AJHajh-20220125-ArunCrem Planning Response_LPA.docx

Y/ 184/ 21/ DOC – CONDITIONS 8, 9 AND 10: DRAINAGE RESPONSE

Thank you for returning comments from your Drainage Engineer pertaining to planning conditions 8, 9 and 10 under planning permission Y/184/21/DOC for the Crematorium, Bognor.

Project No.	Originator	Volume	Lvl/Loc	Type	Role	Number	Rev
13591	CRH	XX	XX	DR	C	5051	P5

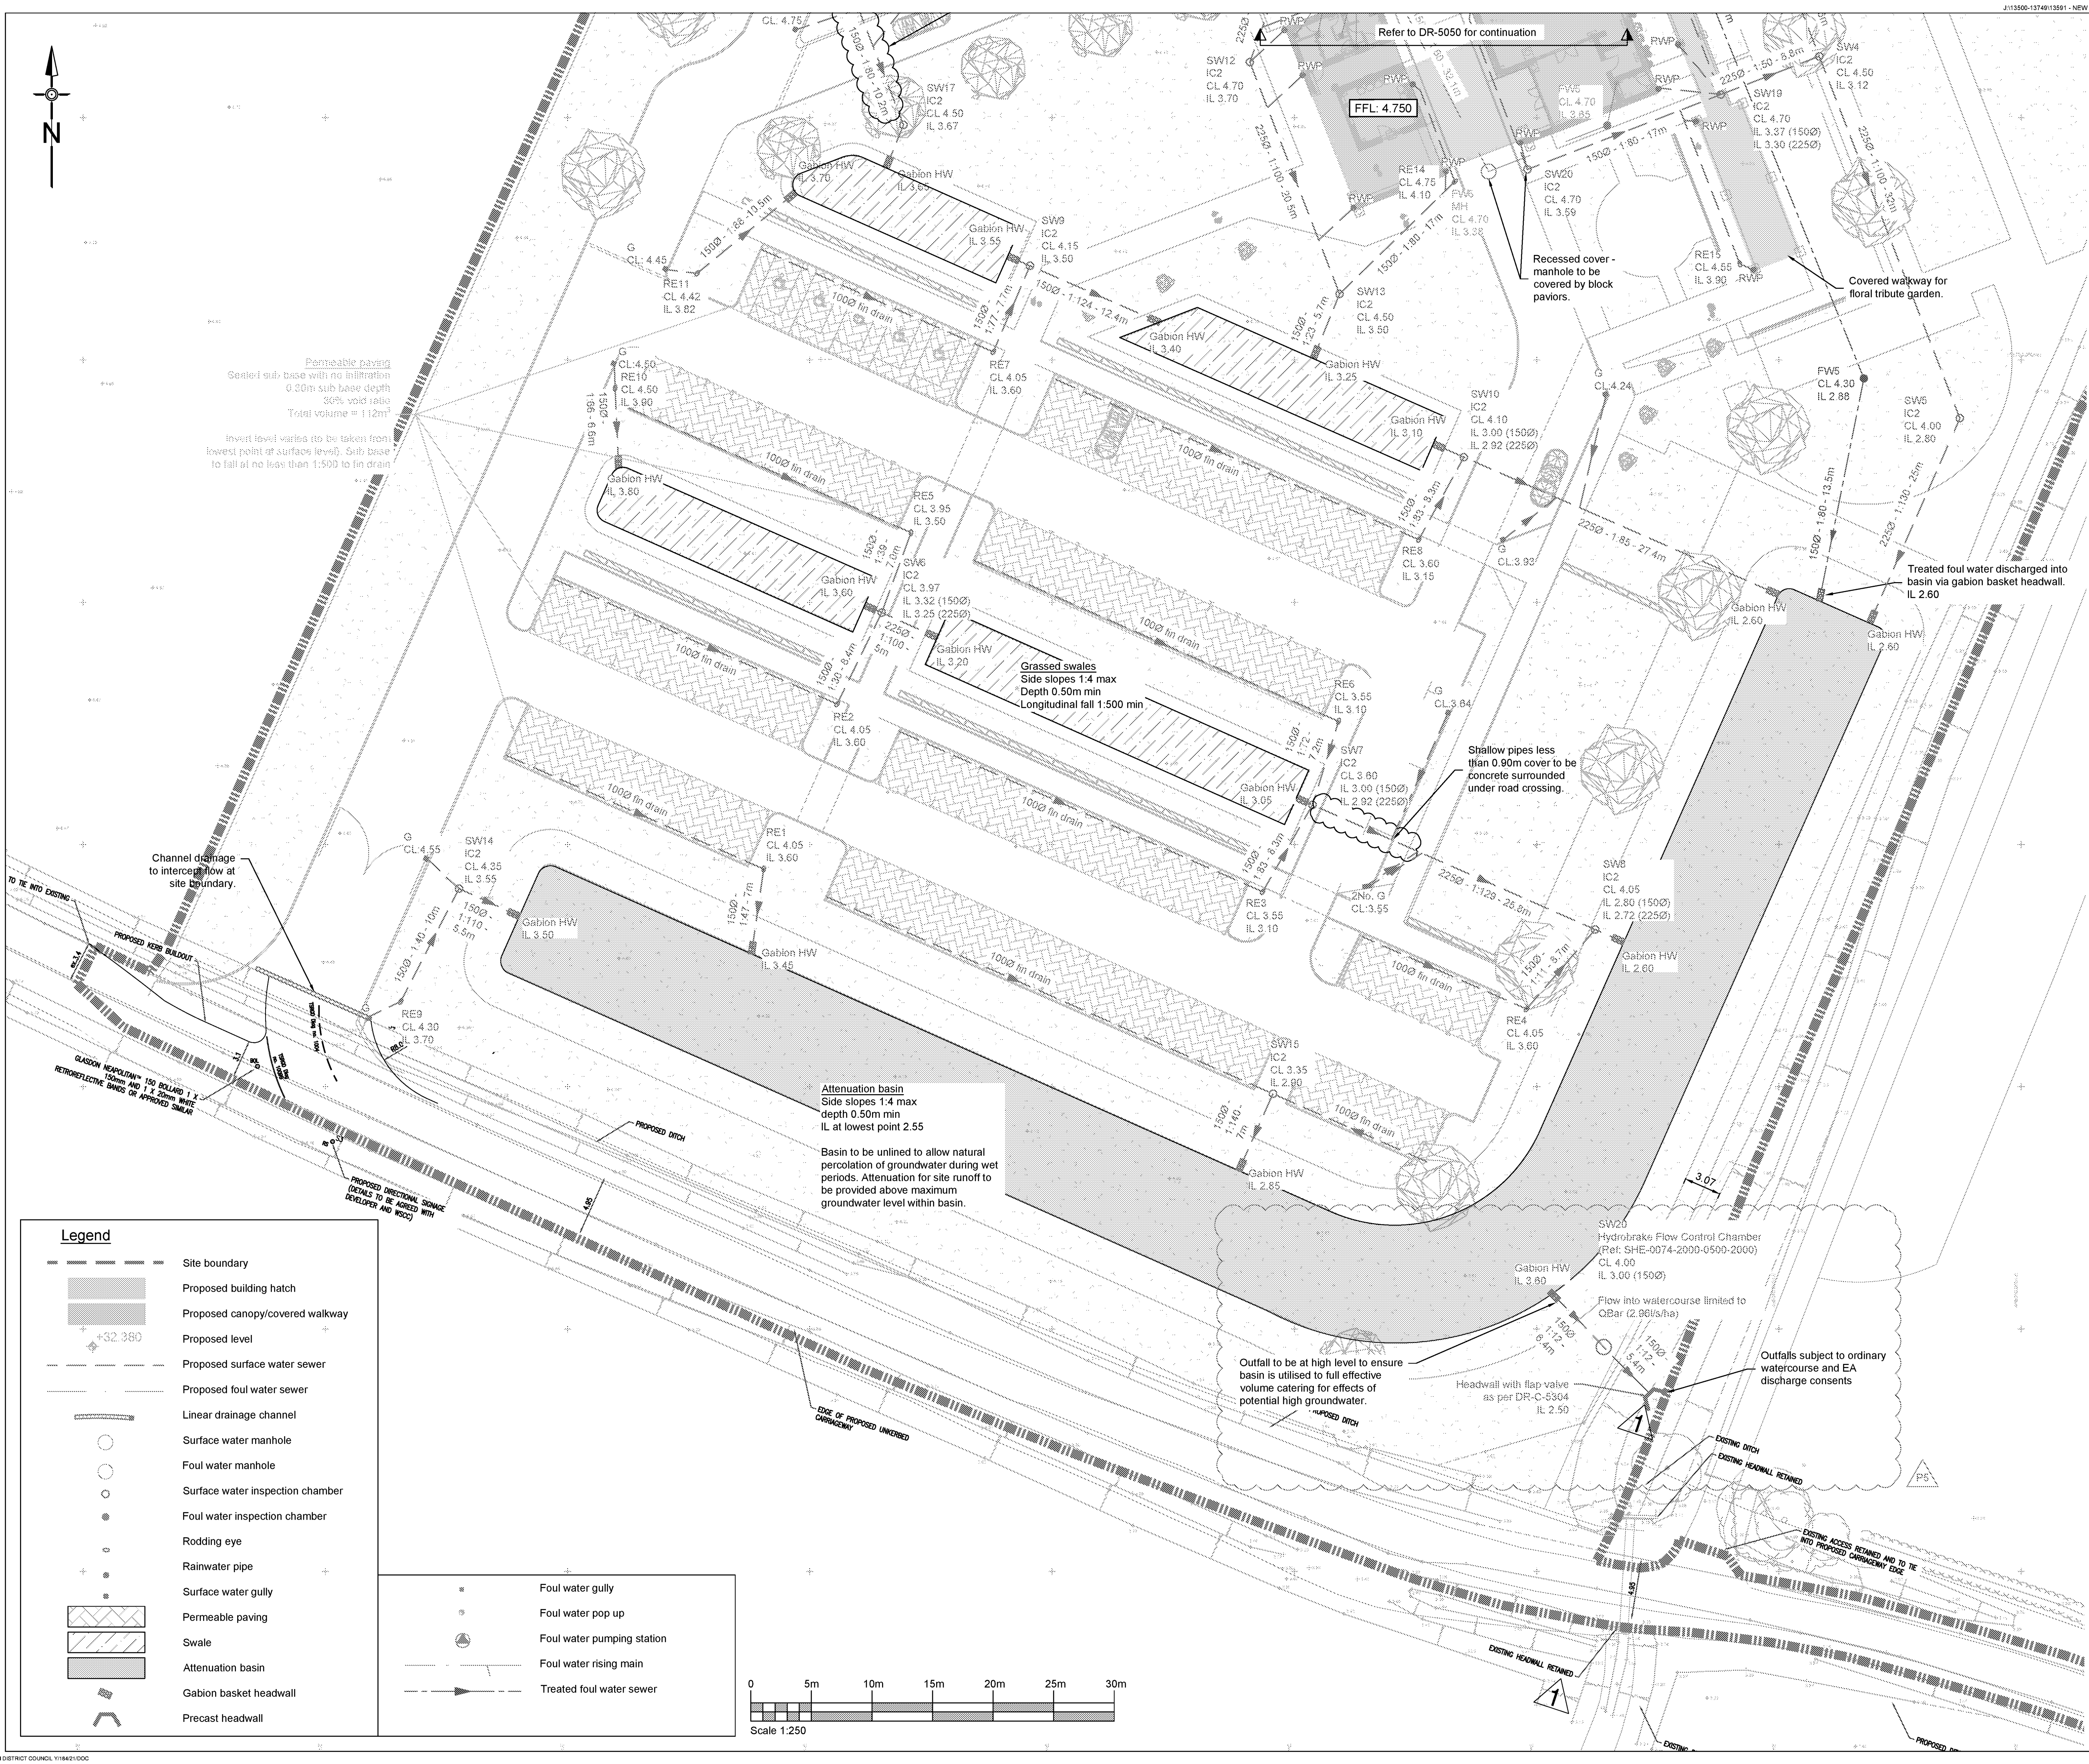
1. Please supply results of winter groundwater monitoring and winter infiltration testing.
2. Please supply calculations to support design.
3. Please supply an impermeable area catchment plan.
4. Please label all pipes with diameter and fall.
5. Hydrobrake unit references should be included on layout plans.
6. Please label finish and formation level of permeable paving.
7. Gullies and channel drains should be labelled with cover levels.
8. The gabion outfall construction detail drawing is unclear. Is it proposed to have buried pipes discharging to the basin?

3. Please see enclosed impermeable area plan 13591-CRH-XX-XX-DR-C-5250 Revision P1.
4. Additional pipe labels have been added to drainage layout plans 13591-CRH-XX-XX-DR-C-5050 Revision P6 and 5051 Revision P5. Gradients for short (<5m) pipe lengths have not been shown. Pipe sizes, maximum grades and materials are to be as specified on drainage notes drawing 13591-CRH-XX-XX-DR-C-5300 Revision P1 previously provided.

5. Details have been added to updated drainage layout plan 13591-CRH-XX-XX-DR-C-5051 Revision P5.
6. Permeable pavement details have been previously provided on detail drawing 13591-CRH-XX-XX-DR-C-5350 Revision P2. This includes depths of proposed pavement build-up. The proposed surface levels can

1. OWC application for the discharge headwall from the basin was formally submitted in September 2021 together with all information requested by Paul Cann as per his email of 11th August 2021. Referring to Land Drainage Act 1991 Section 23(3), could you please confirm when consent letter will be issued?
2. The OWC consent for the new ditch is as shown on the attached consent (Consent Number LDC/ARUN/2021/015)
3. A suitable buffer has been provided between top of basin and edge of watercourse to allow for maintenance, as shown on drawing *13591-CRH-XX-XX-DR-C-5051 Revision P5*.

P5	Revised to suit LLFA comments - pipe details and basin information added	21.01.22	SH
P4	VE updates incorporated. Reissued for Tender	24.11.21	SH
P3	Client comments added. Reissued for tender	15.09.21	AN
P2	Issued for Tender	09.07.21	SH
P1	Issued for Tender	05.07.21	AJH
Rev	Description	Date	By
